## Planning Commission Draft Motion

*Hearing Date:* April 7, 2011  
*Case No.:* **2006.0848E**  
*Project Address:* **25-35 Dolores Street**  
*Zoning:* RTO (Residential Transit Oriented) District  
40-X Height and Bulk District  
*Block/Lot:* 3535/069  
*Project Sponsor:* 35 Dolores LLC  
c/o David Silverman of Reuben & Junius, LLP  
One Bush Street, Suite 600  
San Francisco, CA 94104  
*Staff Contact:* Chelsea Fordham – (415) 575-9071  
Chelsea.Fordham@sfgov.org

## **Planning Department Case No. 2006.0848E**

Preservation Alternative—Schematic Site Plan Figure 10

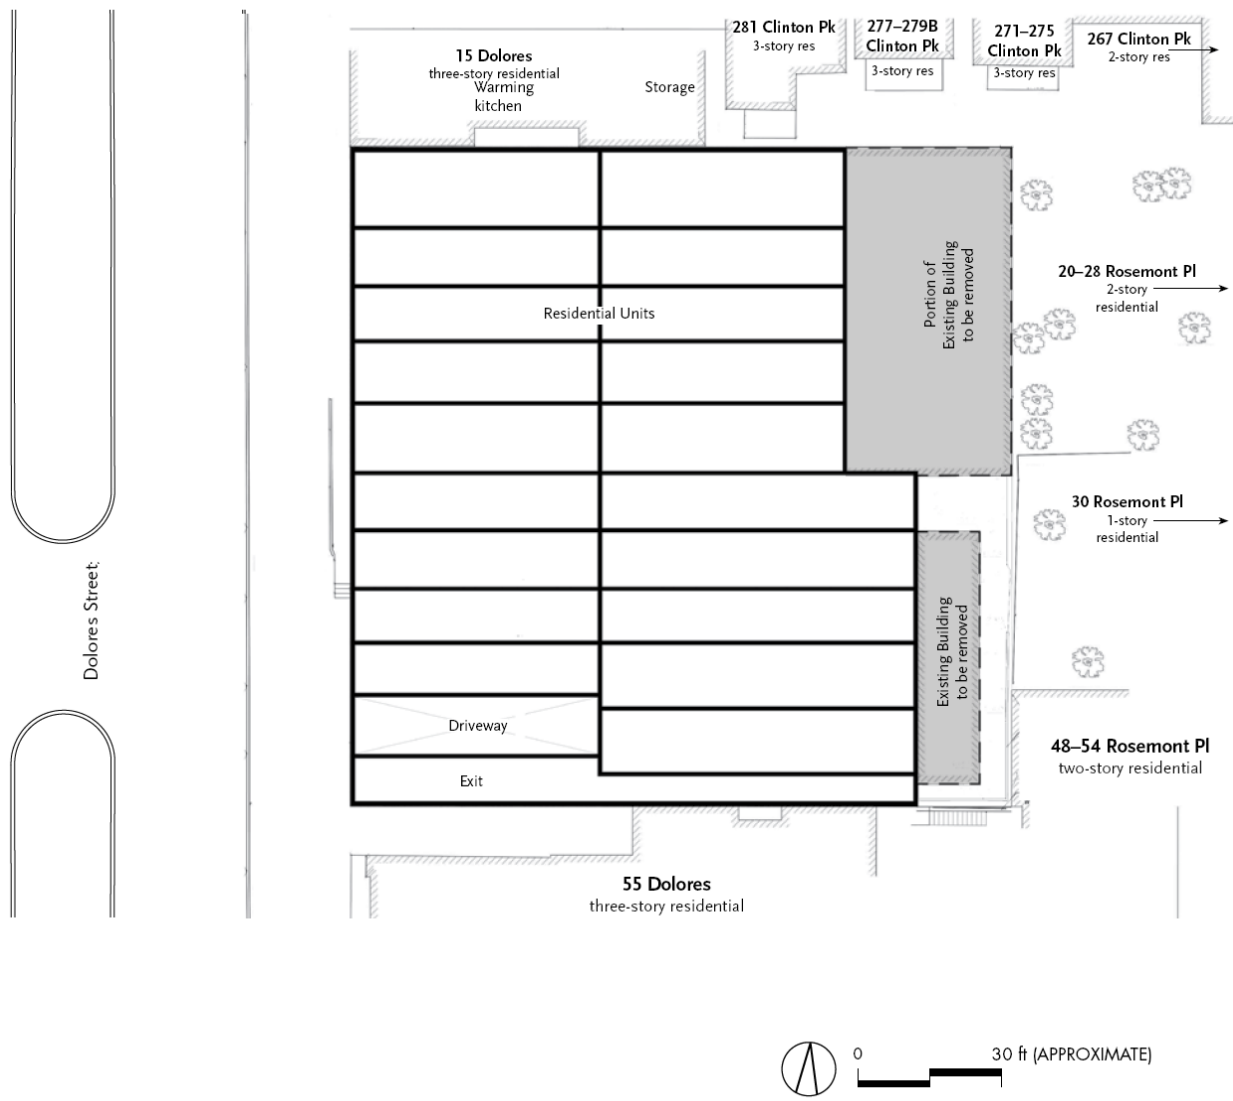
Figure 10, page 59a, illustrates the site plan of Alternative B.

Figure 10, page C&R. 62, is added to the DEIR on new page 59a.

Partial Preservation Alternative – Elevation      Figure 12

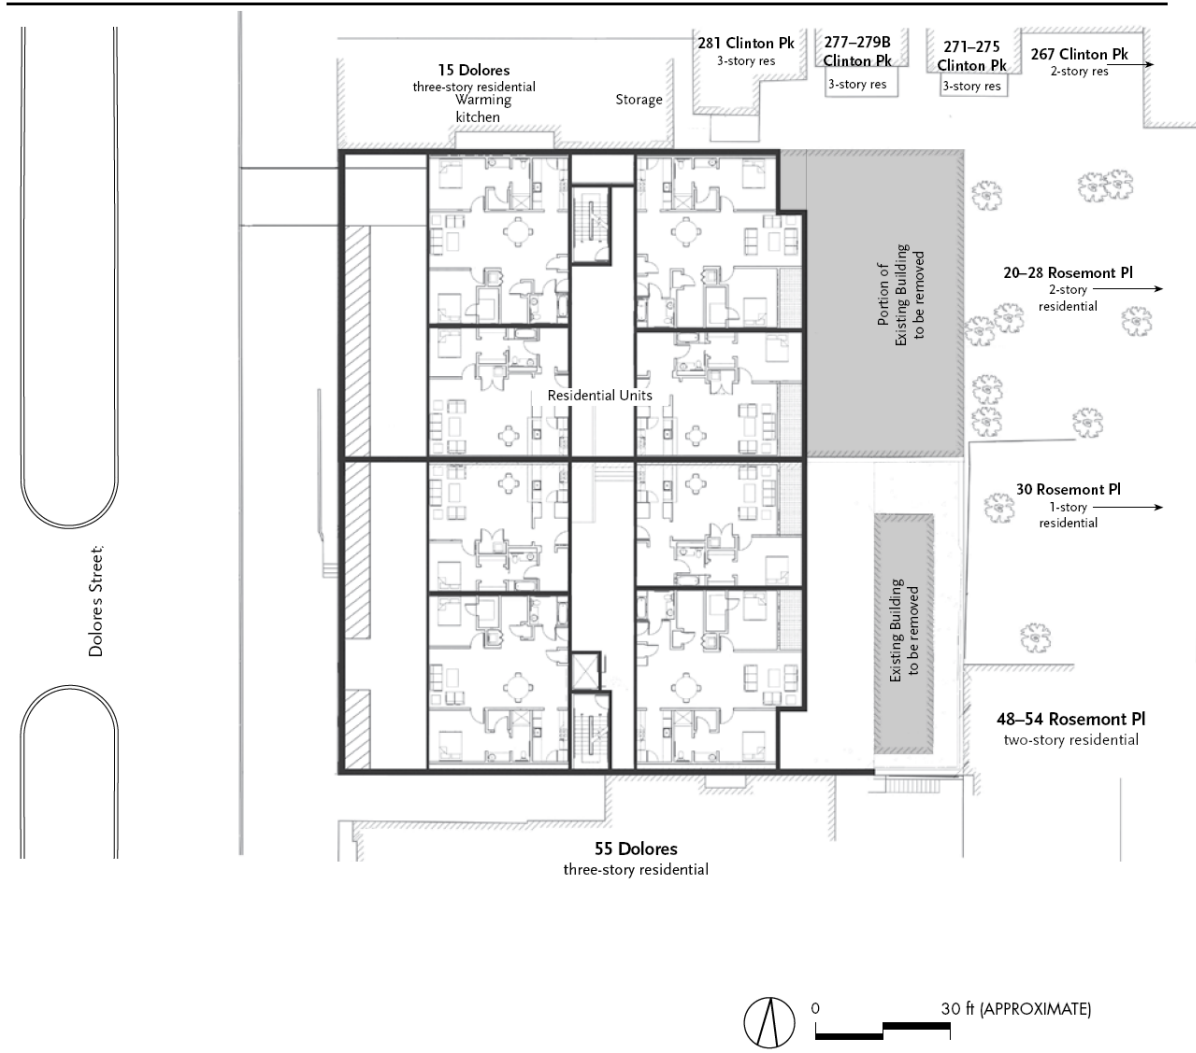
Page 62, Figure 12 of the DEIR, title is changed to:

Front elevation of 23-35 Dolores and 55 Dolores Street. Note that the entryway gate for 55 Dolores is attached to the wall of 23-35 Dolores Street.

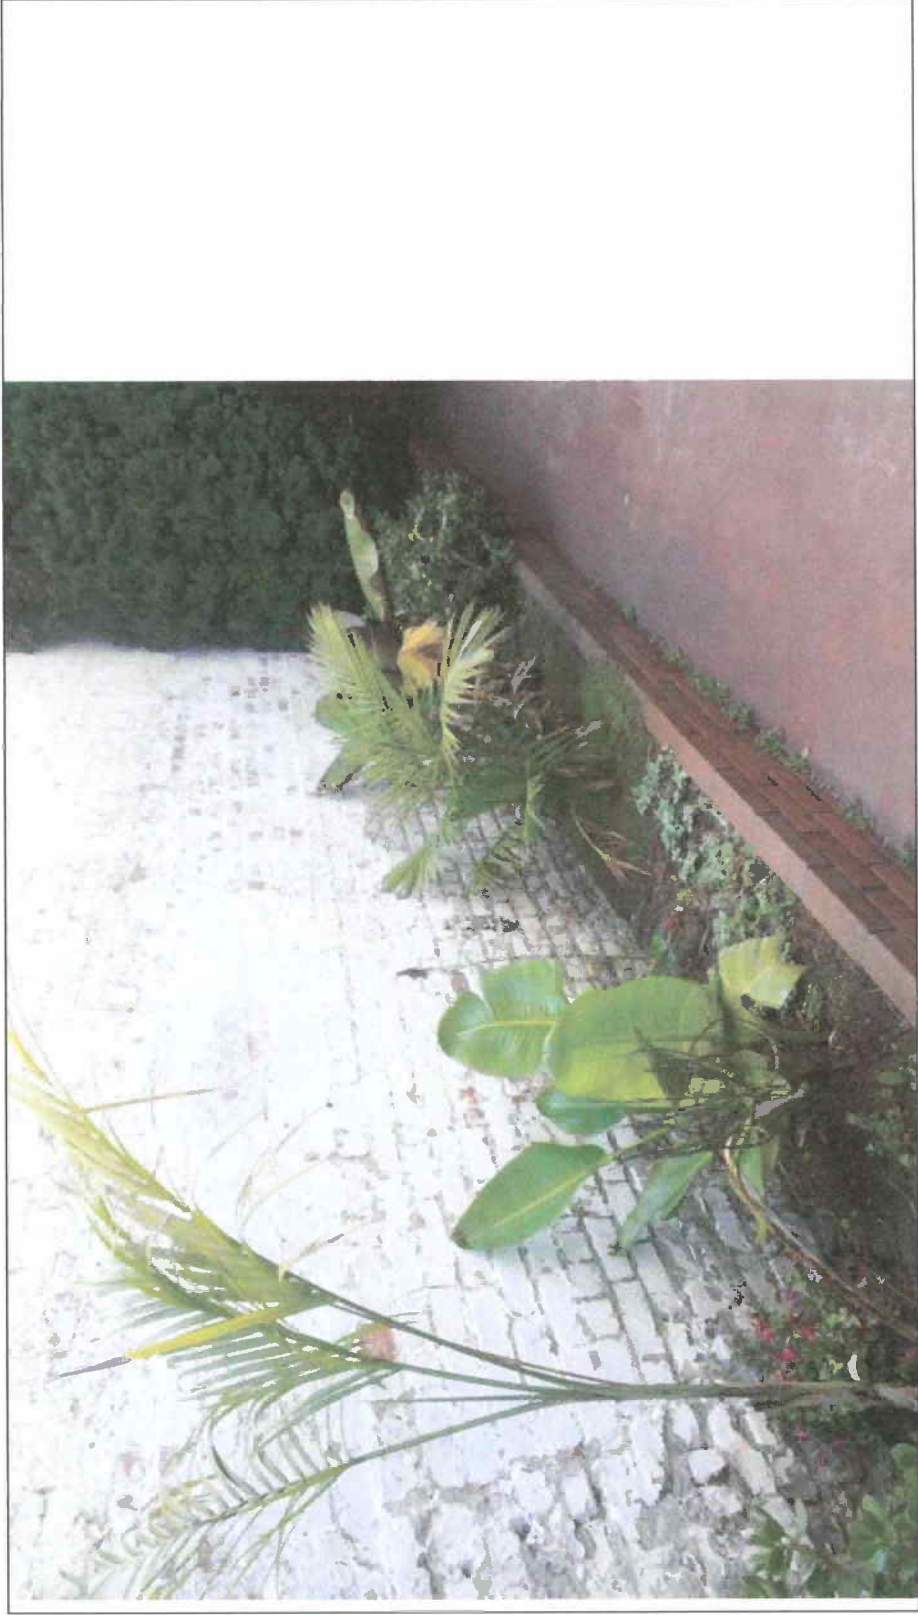
“Strong Potential for Damage to the 55 Dolores Building and Property Infrastructure. As you can see from the photos included at the end of this letter [see Appendix 1 of this C&R document], 55 Dolores Street and the building occupying the 23-35 Dolores Street property are almost literally joined in some sections. The existing brick wall of the 23-35 Dolores property acts as the fence bordering the entry gate, front pathway, and front terrace and rear terrace walls of 55 Dolores Unit #1. Nothing in the current plan provides for an adequate solution to replace this wall that will ensure the building and property infrastructure of 55 Dolores remains whole.” (*Stuart McFaul, Nick Cianci, Manfred MacKeben, Mary Elizabeth Phillips, Sarah Brant, Josh DeClercq, Stephanie DeClercq, written comments*)

“As you might see from the exhibits included at the end of the thicker letter, 55 Dolores Street and the building in question are almost literally joined in some sections.

“Nothing in the current plan provides an adequate solution to replace this wall, that ensures that the building and the infrastructure of 55 Dolores remains whole.” (*Stuart McFaul, oral comments*)

As noted on page 23 of the DEIR, the project would require approval by the Department Building Inspection (DBI) for demolition and building permits. As a part of this approval process, DBI would verify that project design plans (which are not finalized at this time) comply with all applicable *California Building Code* requirements, including adequate structural design, seismic safety, performance requirements for exterior walls, and many other code requirements developed to ensure building stability and occupant safety. These requirements will also apply to any potential effects development of the project would have on the adjacent property at 55 Dolores Street. Therefore, DBI review would ensure that 55 Dolores does not withstand structural damage from the proposed construction of 25 -35 Dolores Street.

remove the existing wall in sections, supporting the existing structures as they went along. Because the project site is underlain with groundrock, dirt movement is not anticipated. Other neighboring structures, where they are directly adjacent to the existing buildings at the project site, would be supported the same way.
